- 10. Patsy's Creek 2022 Replat; KPB File 2022-073
Geovera, LLC / Kusnetsov
Fitz Creek Area / Kachemak Bay APC**

ITEM 10 - PATSY'S CREEK 2022 REPLAT

KPB File No.	2022-073
Plat Committee Meeting:	July 18, 2022
Applicant / Owner:	Alexandre and Marfa Kusnetsov of Homer, AK
Surveyor:	Stephen Smith / Geovera LLC
General Location:	Wynn Lane, Morrison Drive, Fritz Creek / Kachemak APC

STAFF REPORT

PATSY'S CREEK 2022 REPLAT

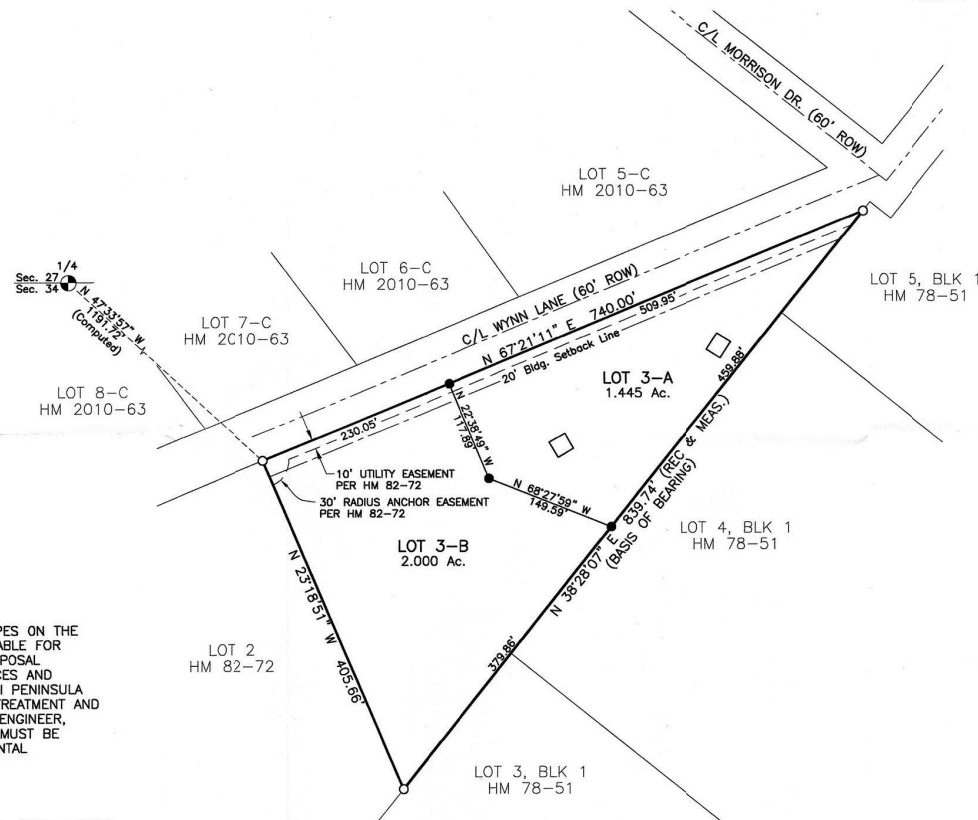
The terrain within the dedication of Wynn Lane do not appear to contain steep slopes but per KPB Code grades shall not exceed 6 percent on arterial streets and 10 percent on other streets. Per KPB GIS data, it appears there may be portions of the right-of-way with slopes around 18 percent. **Staff recommends** documentation be presented that the slopes comply or provide centerline profiles to determine if any additional right-of-way width will be required or additional easements for maintenance and slopes.

There are two structures being shown on the preliminary plat. There does not appear to be any encroachment issues. **Staff recommends the structures may be removed from the final plat.**

Utility Easements Patsy's Creek, Plat HM 80-59, granted a 10 foot x 30 foot anchor easement in the northeast portion of the original tract. Patsy's Creek No. 3, Plat HM 82-72, dedicated a 50 foot width of Wynn Lane atop the easement. **Staff recommends the surveyor verify that there are no portions of the easement remaining.**

Staff recommendation: *The Certificate to Plat and deed indicate title was taken by Mr. and Mrs. Kusnetsov. She will be required to be added to the title block and signature lines unless documentation is presented that she is unable to sign.*

Staff recommendation: *Wynn Lane appears to have some portions that with approximate 18 percent slopes. The right-of-way is not currently constructed and will the dedicated access to Lot 3-B. Staff recommends cross sections be provided to determine if additional width will be require or possible slope easements.*

Platting Staff Comments: Soils report will be required and the plat must be signed by licensed engineer.

Plat note 6 may be removed as there are no wetlands within the proposed subdivision.

Staff recommendation: The Certificate to Plat and Deed indicate the ownership was taken by husband and wife. Unless documentation is provided, Mrs. Kusnetsov will need to have a signature line added and the Certificate of Ownership will need to be revised to plural pronouns. Comply with 20.60.190.
